Board of Zoning Appeals

Tuesday, April 14, 2026

ZVAR-0326-000009 1350 Northmeadow Parkway Unit:130

Variance for relief from the screening requirement for ground-mounted equipment, as required by UDC 10.2.8.D

TEST AREA ELEVATION
SCALE: 1/2" = 1'-0"

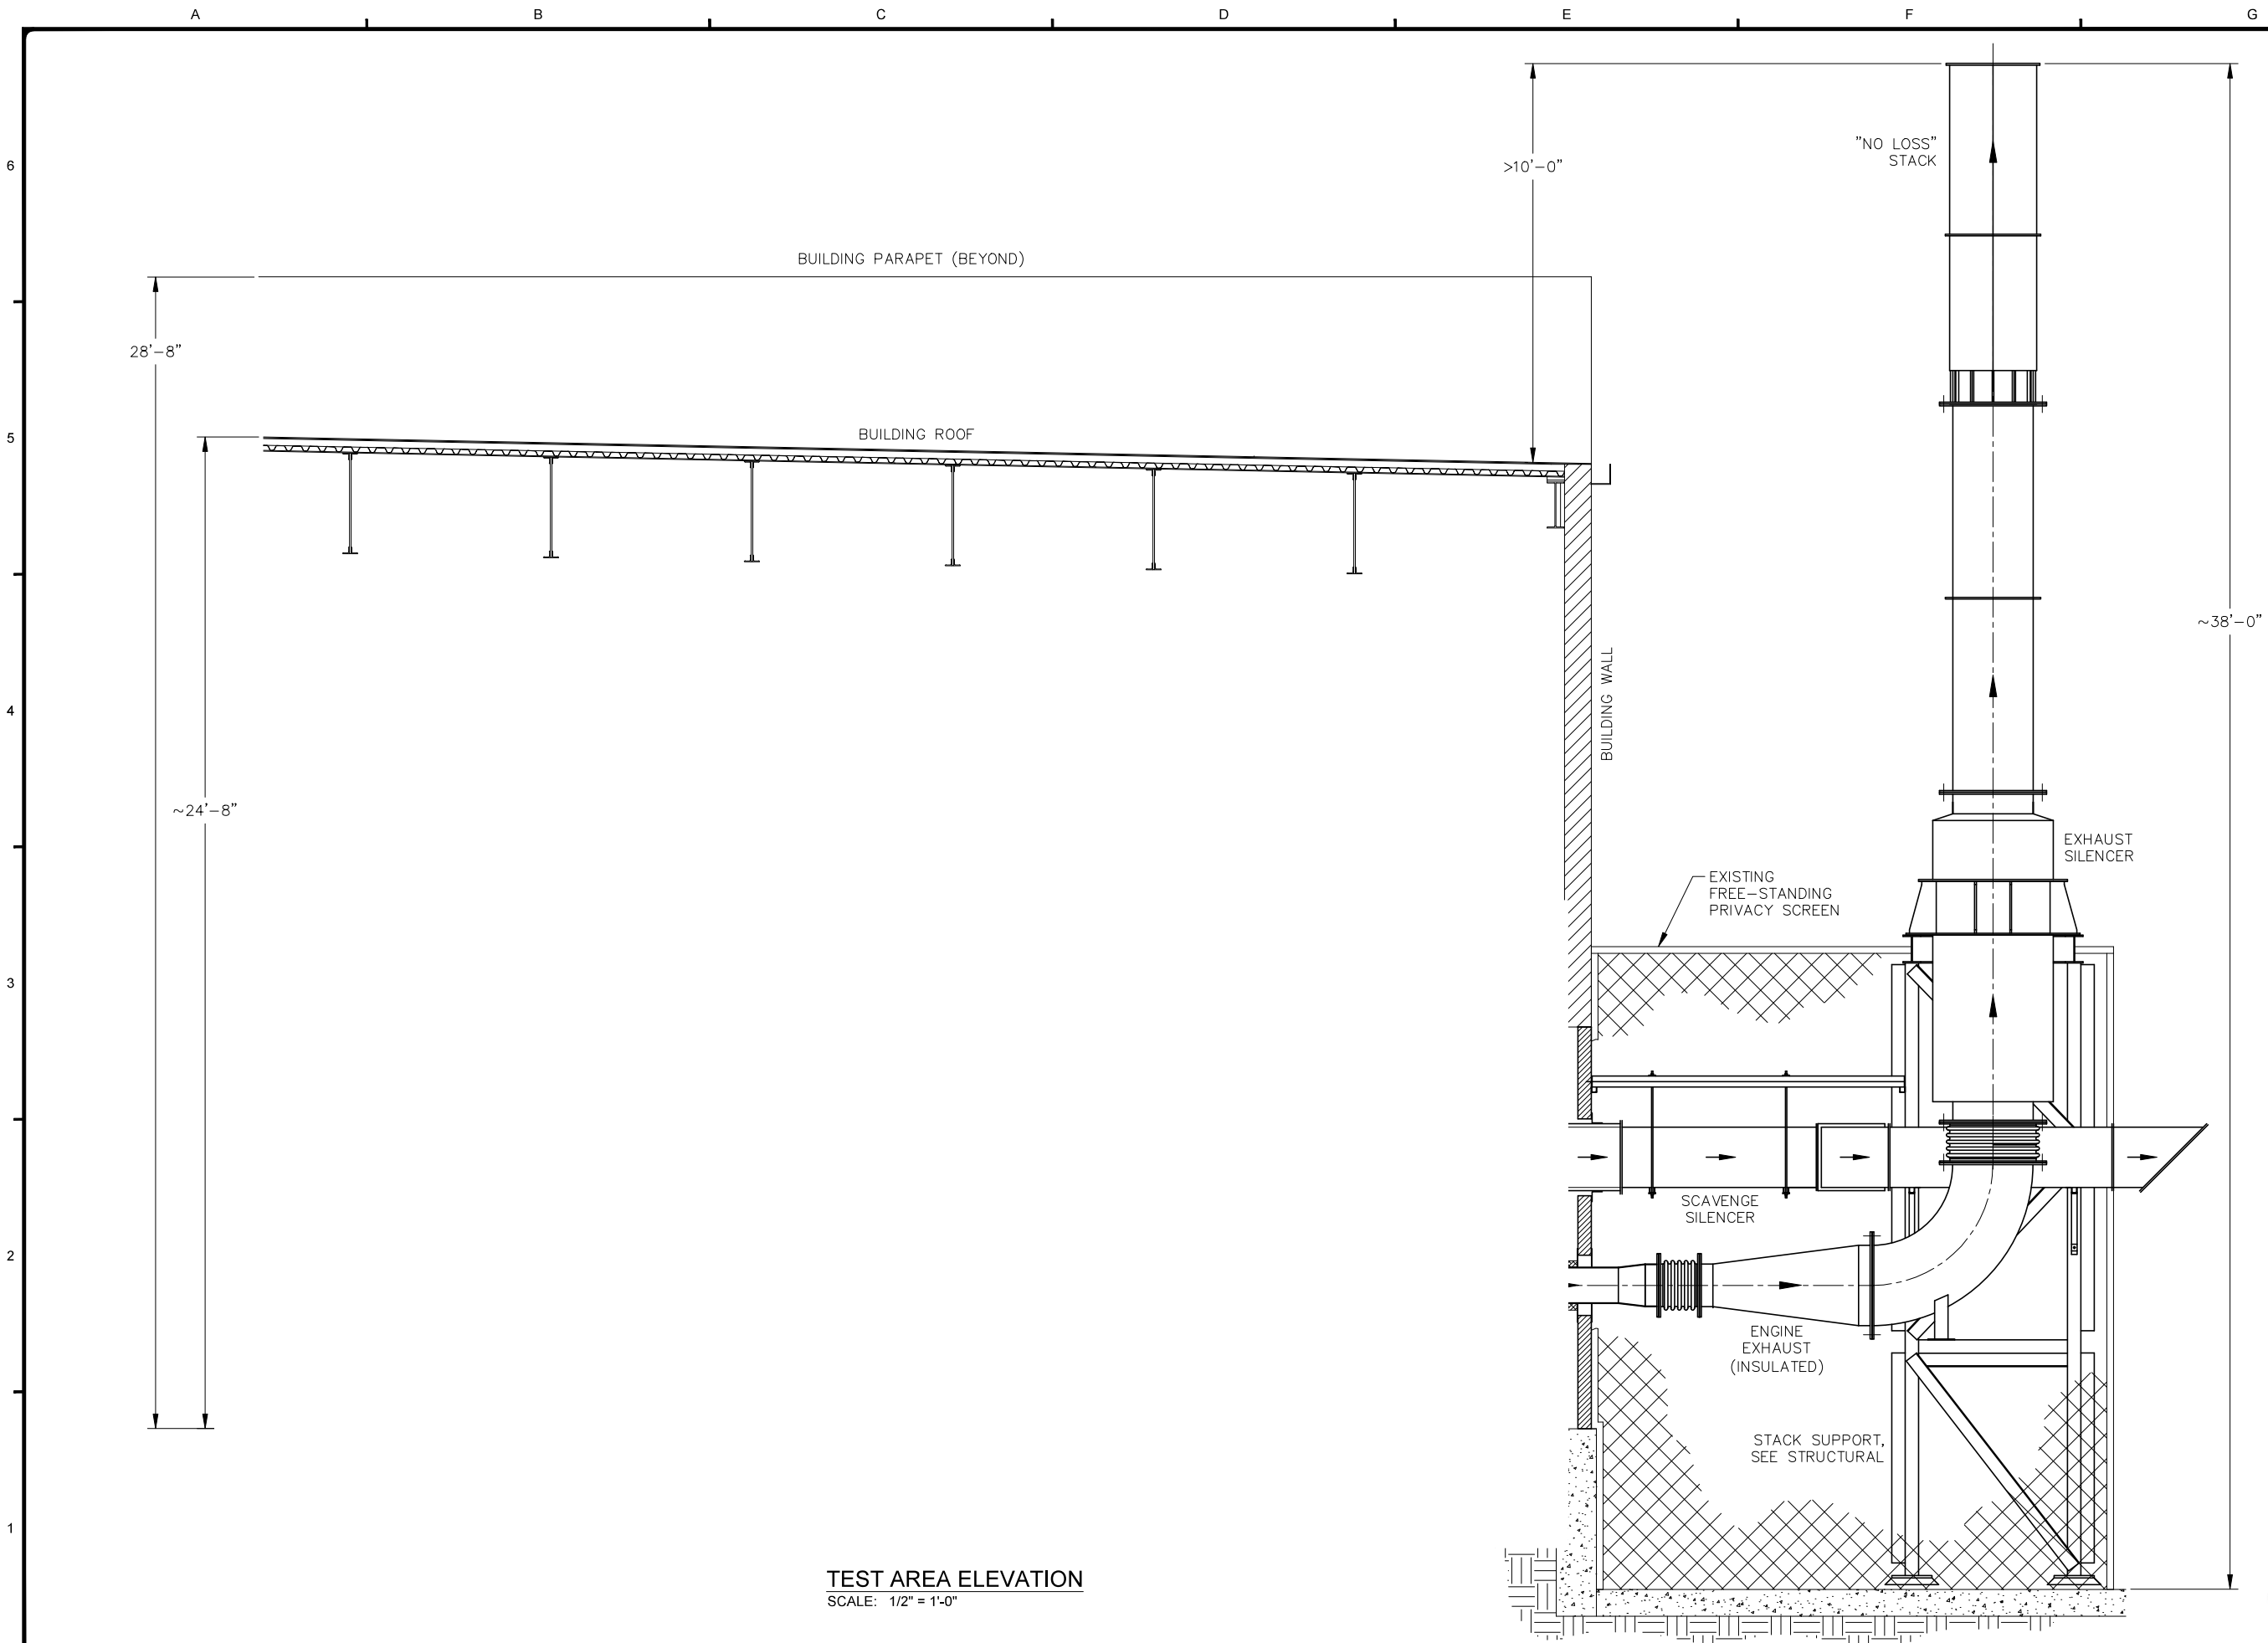
1. The relief from screening requirement does not apply to any structure over 38 feet; and,
2. The relief from screening requirement only applies to the ground-mounted equipment, as shown on the elevations received by the City on May 25, 2026.

Screening would still be provided up to at least 16 feet high, for the 38 foot high exhaust stacks. This would leave the upper 22 feet of the proposed exhaust stacks visible from Hembree Parkway.
